Response to NRW Comments

197424-F01 Rev C | 13th November 2024

Unit 1, MPN House, The Ponds, Ynyscorrwg Road, Glyncorrwg, Port Talbot, SA13 3EA

4 Response to NRW Comments – 30th August 2024

Figure 1 – Modelled 1 in 100 +CC year depth at the location of the proposed building

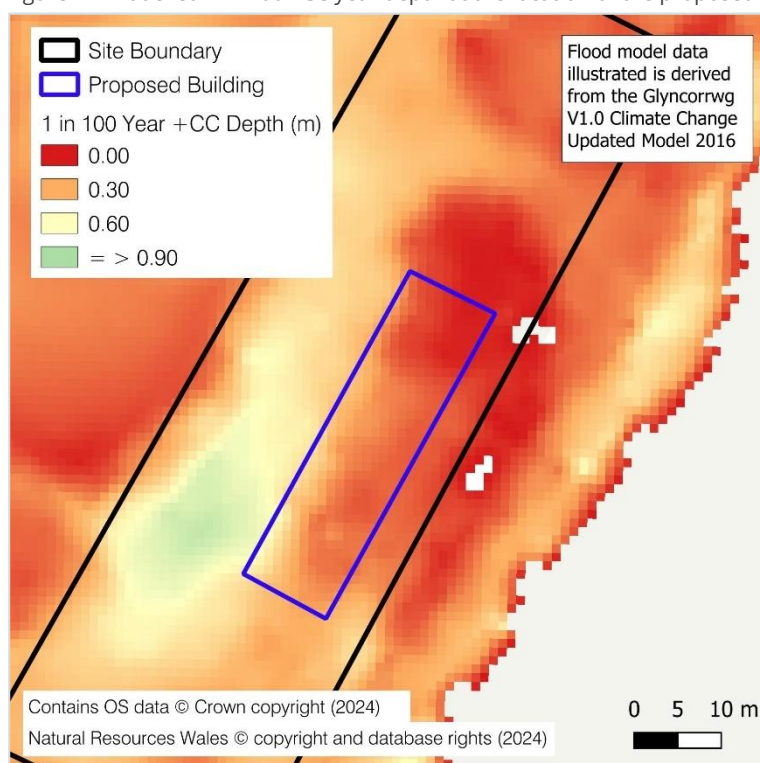
'The FCA has failed to demonstrate compliance with A1.14 of TAN15 in that the site is at fluvial flood risk in the 1%+CC fluvial flood. Whilst the site is also impacted in the 0.1% fluvial flood, the flood depths are within the tolerances of A1.15.'

Figure 1 illustrates the modelled flood depths at the location of the proposed building at the 1 in 100 +CC year event. As shown in Figure 1, flood depths are shown to be less than 300mm within the majority of the location of the proposed building.

The Finished Floor Level (FFL) of the proposed building should be raised to a level of 209.92mAOD. This is the maximum modelled flood level at the location of the proposed building at the 1 in 100 +CC year event. This will ensure the building remains flood free during this event. Flood resilience measures would also be integrated into the building's design up to a level of 210.39mAOD, which is the maximum modelled flood level at the location of the proposed building at the 1 in 1000 year event plus a 0.3m freeboard. This provides a greater level of freeboard above the 1 in 100 year +CC event for additional protection.

Figure 2 – Area available to provide compensatory storage

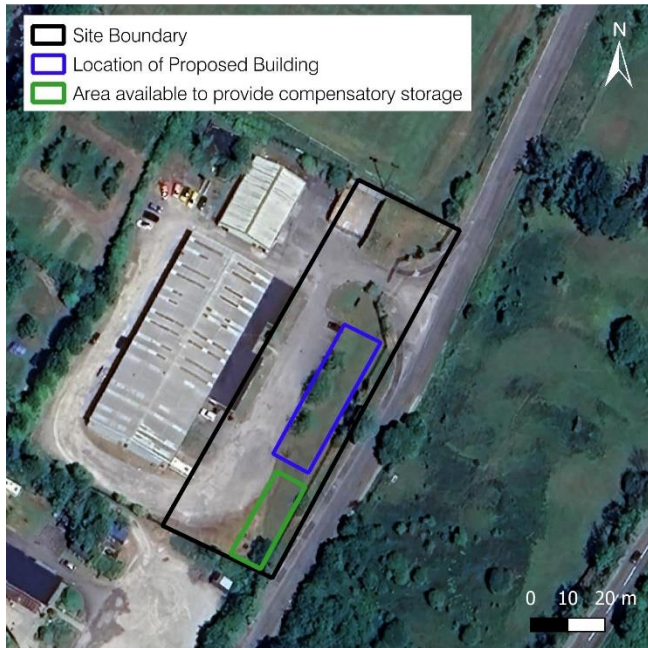
'Given the fluvial flood risk to the site any new built development has the potential to cause an increased flood risk elsewhere, the FCA has failed to demonstrate compliance with Table A1.12 of TAN15 in relation to this matter.'

Based upon the proposal to set the internal finished floor level (ground floor) at 209.92mAOD, this would potentially cause a minor increase in displacement of flood water should such a flood event occur. Fortunately, an area directly to the south-west of the proposed development footprint and to the south of the proposed attenuation basin is available to provide compensatory flood storage should such an event occur. Figure 2 below demonstrates the location and extent of this area.

Based upon the close proximity of this area to the proposed development, and the large footprint that is available to be utilised within the wider site boundary, a cut and fill exercise would be undertaken to ensure a like for like volume of compensatory storage is made available at the 1 in 100 year +CC flood event. This exercise would be completed prior to commencing construction of the development and can be conditioned.

PROPOSED FLOOD COMPENSATORY STORAGE

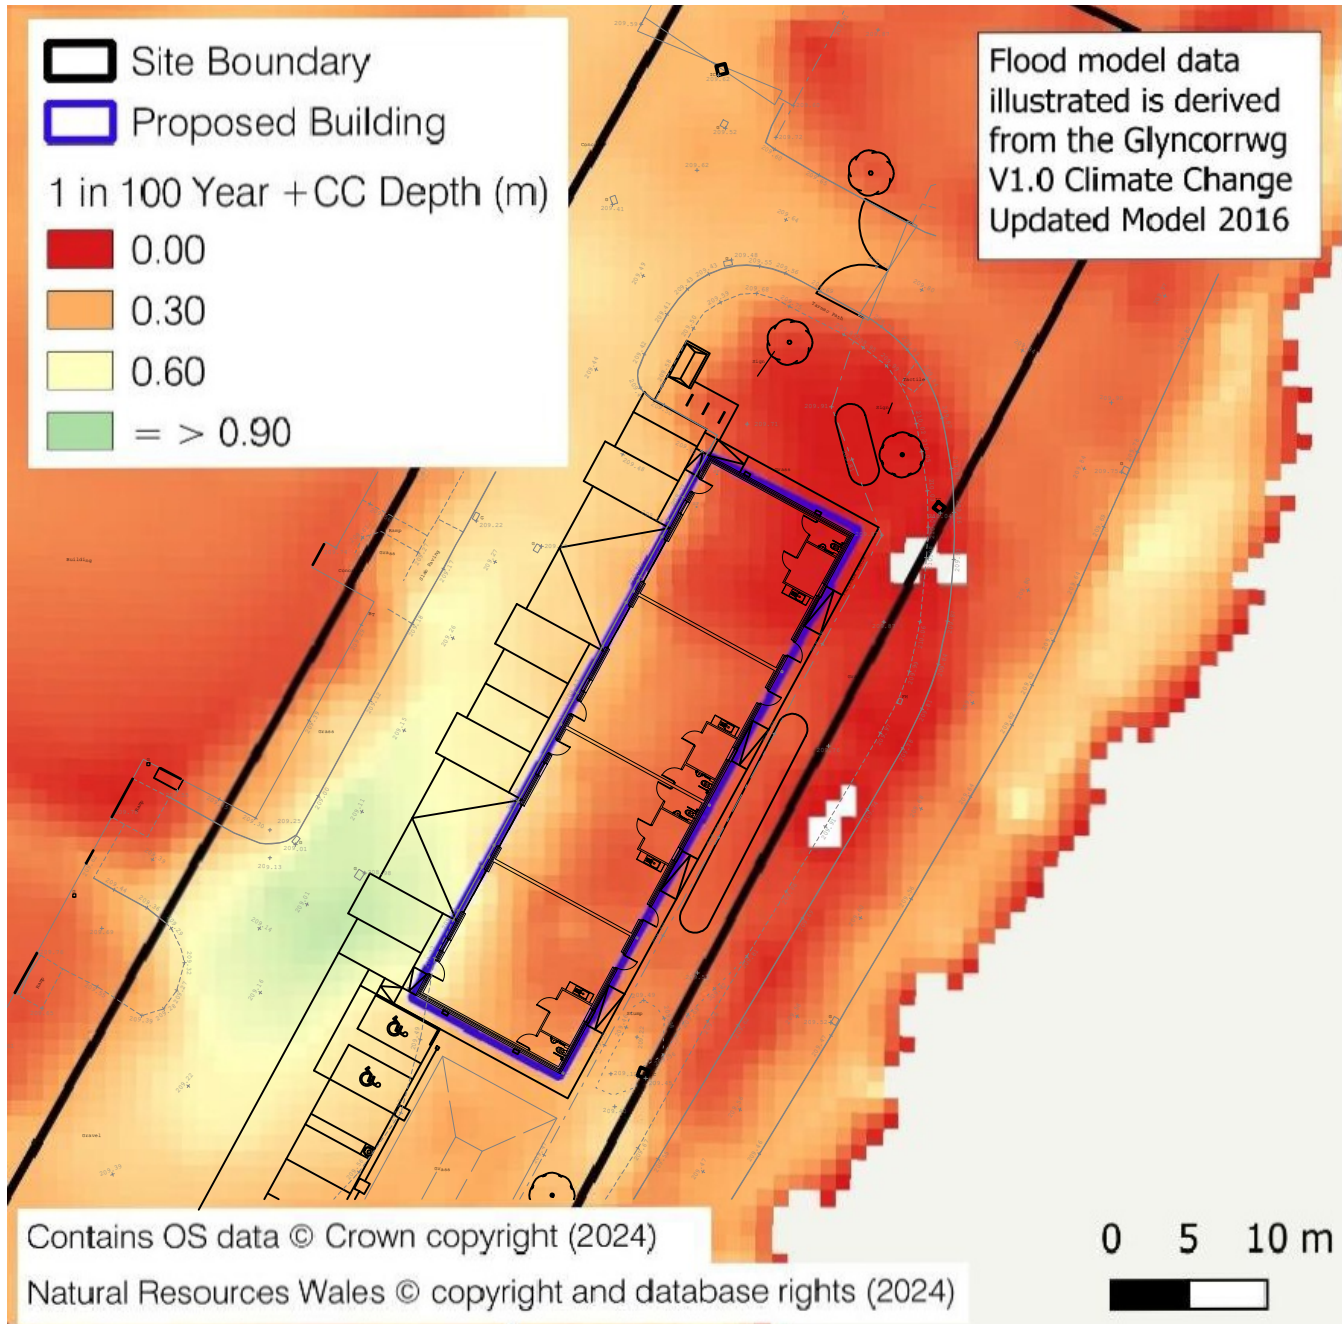
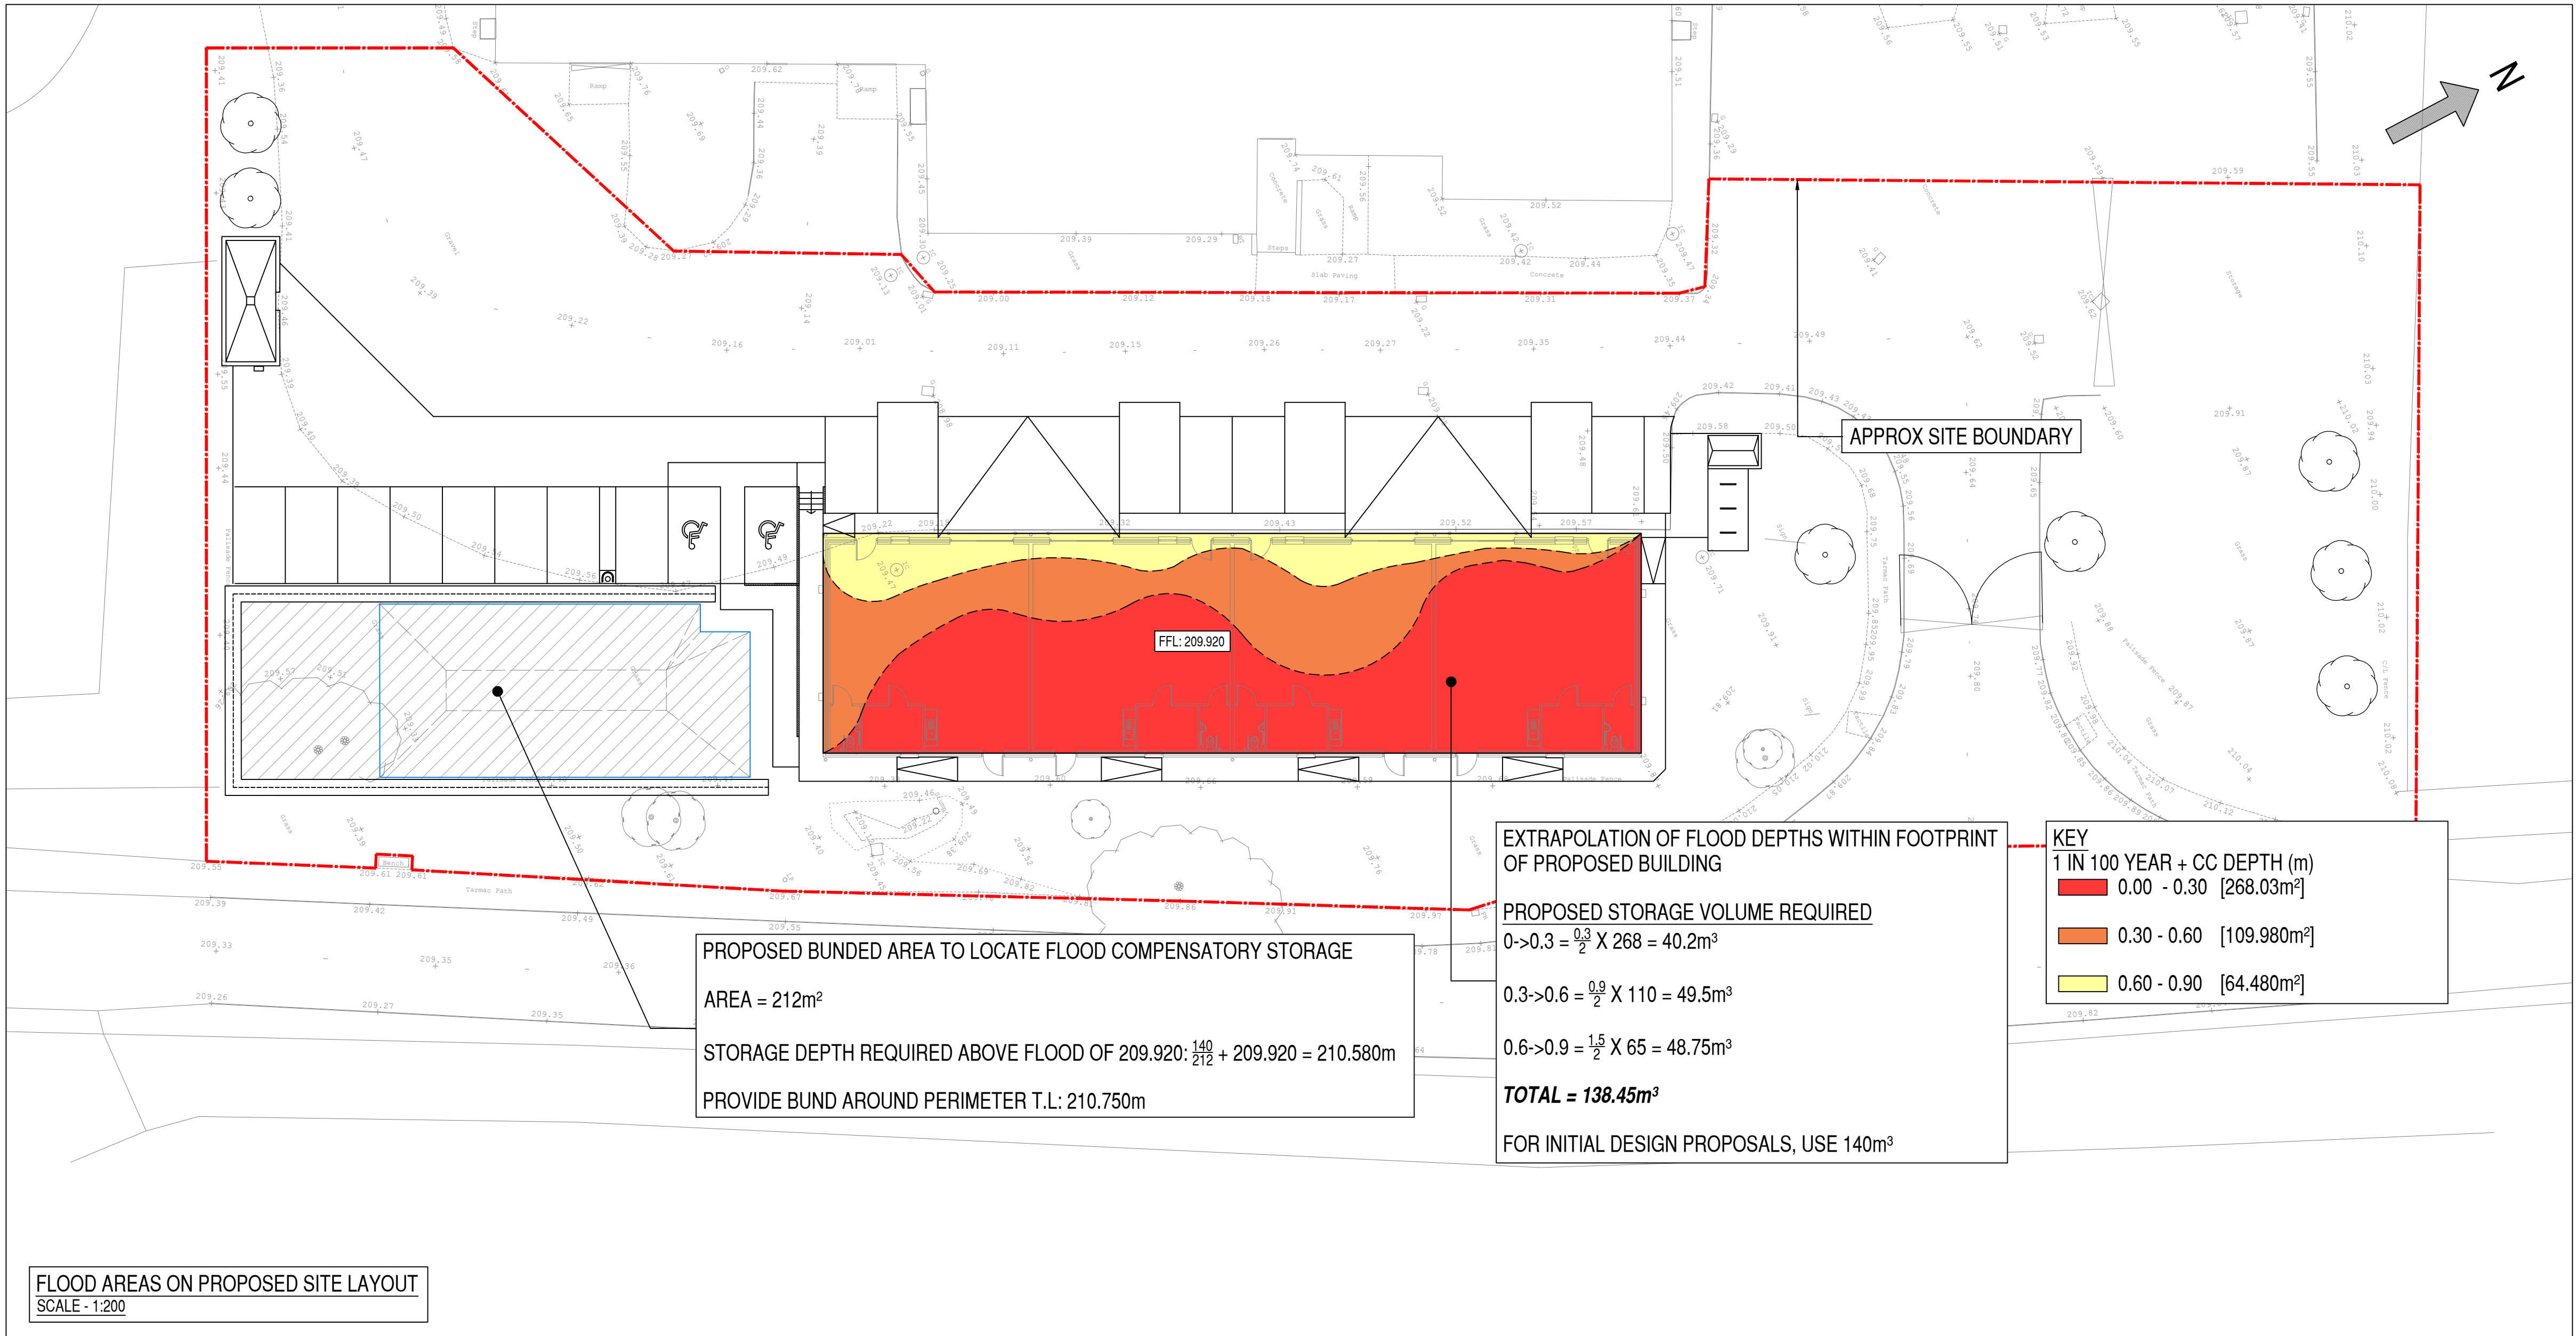
Comment 2: *With regard to the potential to cause an increase in flood risk elsewhere and compliance with A1.12 of TAN15, we note the proposal to create an area of 'like for like volume of compensatory storage' however, no evidence has been provided to support the efficacy of this mitigation measure. We must also highlight that due to the proposed compensatory storage being located within the fluvial floodplain the efficacy of the proposed mitigation may be difficult to demonstrate.*

We note NRW's comment that the site is wholly located in the projected floodplain. However, the intention to store volume for volume, like for like ("VfV & LfL") storage is possible by transposing the volume of flood water that will be displaced by the new building footprint plus footpaths directly to the portion of open ground to the south, where the detention basin is currently located.

This transferal of the displacement on a VfV & LfL is achievable by creating an elevated flood storage area directly adjacent and "downstream" of the building position (see APPENDIX C - PROPOSED FLOOD COMPENSATORY STORAGE). The VfV & LfL "area" will be positioned effectively above the existing surface water detention basin and also include the portion of land to the south, all of which will be within the boundary of the site.
